MOD2025/0472

PROJECT ADDRESS
29 CONDOVER STREET NORTH BALGOWLAH 2093

DRAWING NO.
CC13

DRAWING NAME
SOUTH ELEVATION

1 SOUTH ELEVATION - SIDE 1:100

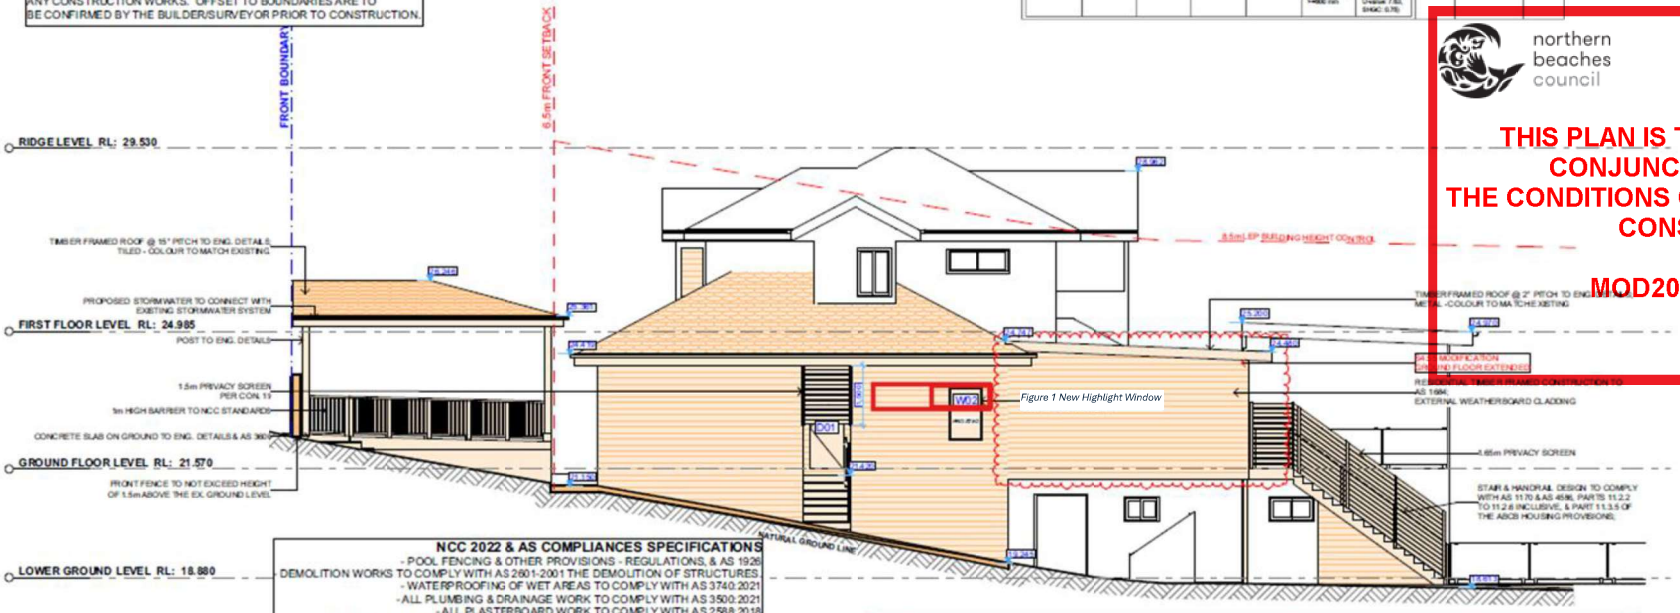
B. Modify Condition 14. Amendments to the approved plans to read as follows: The following amendments are to be made to the approved plans:
The front fence shall not exceed 1.5m above the existing ground level.
W02 on the south elevation shall be non-operable and utilise frosted glazing.

Condition 19: A 1.5 metre privacy screen attached to the underside of the eave and flush with the adjacent walls is to be erected for the entire width of the dwelling entrance stairway on the south elevation. The privacy screen shall be of fixed panels or louvre style construction (with a maximum spacing of 20mm), in materials that complement the design of the approved development

Condition 20b: Provide updated plans detailing the following: · A 1.65 metre privacy screen is to be erected for the entire length of the outermost southern edge of the external stairs located off the Deck as shown on the approved plans. The privacy screen shall be of fixed panels or louver style construction (with a maximum
